Terex Utilities

PRODUCT NOTICE

PN674

SUBJECT: *Dielectric Monitoring Circuit*

Figure 2

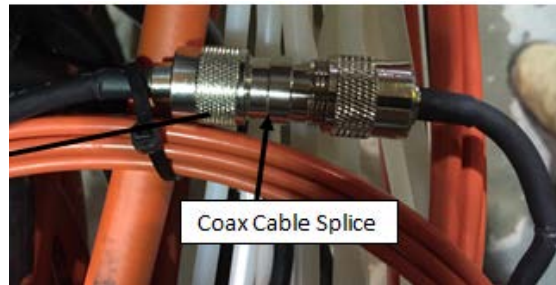
The monitoring circuit wiring at the elbow of TM 125 category A & B aerial devices has the coax cable connected to the upper boom hose carrier bulkhead plate, which may increase the leakage current reading or the chance of the coax cable fatiguing. Failure of the coax cable will cause the monitor circuit to show no leakage, when tested, causing a work stoppage until repaired.

1. Inspect the coax cable connection style at the knuckle to determine if this bulletin applies to your equipment.
 - a. This bulletin applies to coax cable connection with a bulkhead connection as shown in Figure 1.

- b. This bulletin does not apply to the coax cable connection as shown in Figure 2.

2. Where this bulletin applies, the bulkhead connection must be removed and replaced with coax cable union connection, as shown in Figure 2. Contact Terex Utilities; through your nearest TEREX Utilities dealer as shown on the web site, terexutilities.com, call TEREX Utilities Warranty, at 1-844-837-3948 or by email at utilities.warranty@terex.com to arrange for repair or replacement.
